MEMORANDUM FOR MILITARY/INDUSTRY DISTRIBUTION

SUBJECT: Initial Draft of MIL-PRF-8805 /11J, /14F, /15G, /17G, /18G, /19F, /23G, /25F, /34E, /38G, /40H, /47G, /48H, /49H, /65D, /76H, /84E, /90F, /96E, /100F, /101K, /104C, /107C, /110D, and /114C.
Project numbers 5930-1838 through -1863.

MIL-PRF-8805/84E

M8805/84-003

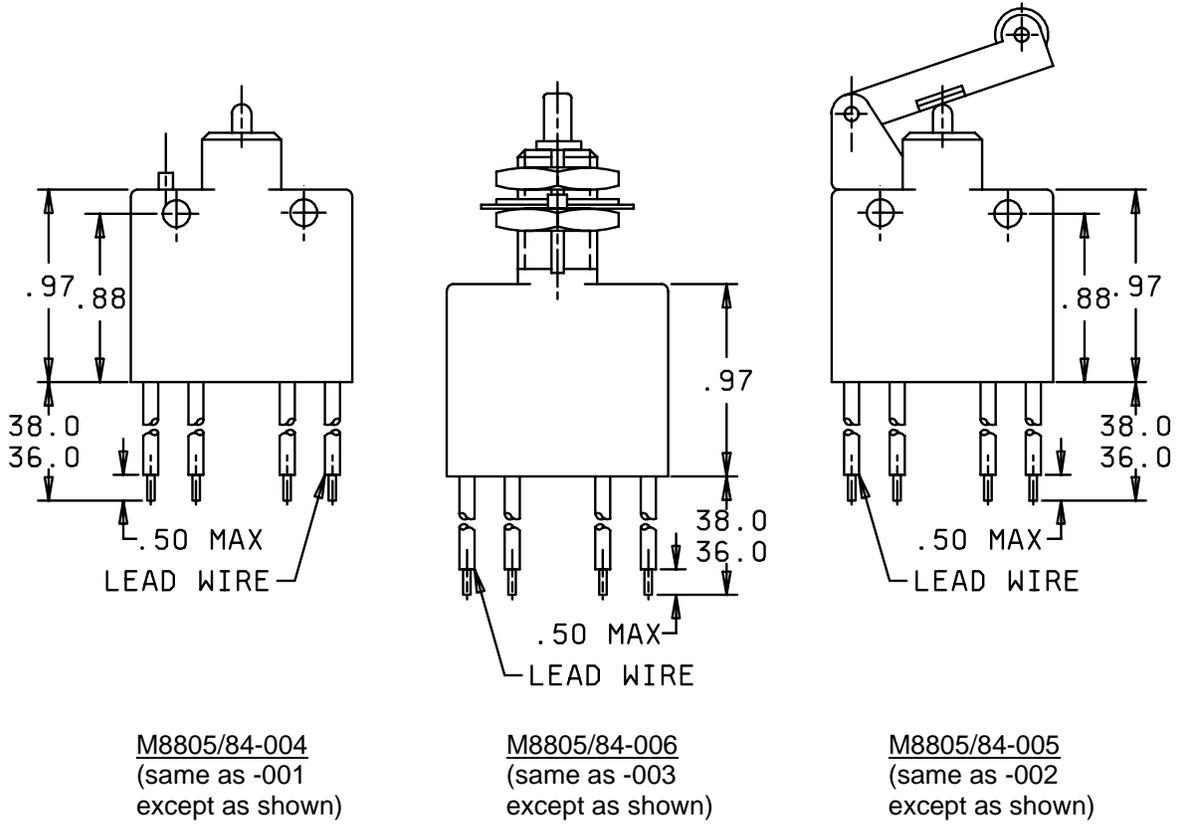
Can be replaced by NASM 35333-134
